**Report: TAB Punch-List**  
**Function: Test, Adjust, & Balance**  
**Date: 07/10/2025**  
**Completed By: National TAB**

## Conner HS Fieldhouse (Hebron, KY)

Project: Conner HS Fieldhouse (Hebron, KY)

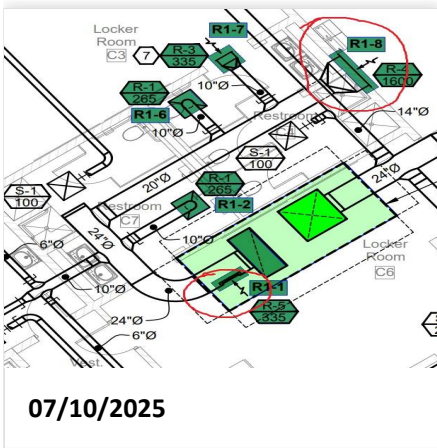
**Issue Name :** ERV 1 Exhaust  
**Description :** Restrictive ductwork on the exhaust duct for restroom C7 preventing exhaust flow.  
**Created By :** National TAB                      **Assigned To :** National TAB - Nick Payne  
**Status :** Open  
**Priority :** Medium                                      **Asset Tag :**  
**Originated Date :** 07/10/2025 - Gabe Merk - National TAB

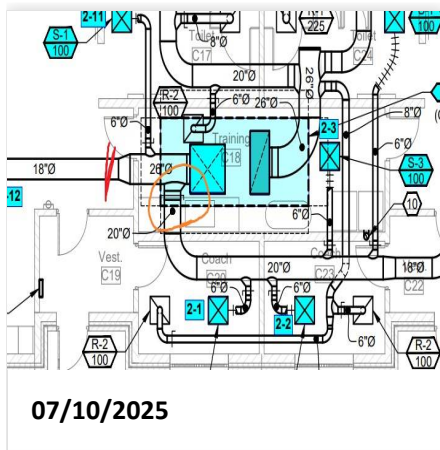
**Issue Name :** ERV 1 Exhaust Dampers  
**Description :** Two exhaust grilles on ERV 1 are missing dampers. Unable to distribute flow to other individual grilles.  
**Created By :** National TAB                      **Assigned To :** National TAB - Nick Payne  
**Status :** Open  
**Priority :** Medium                                      **Asset Tag :**  
**Originated Date :** 07/10/2025 - Gabe Merk - National TAB
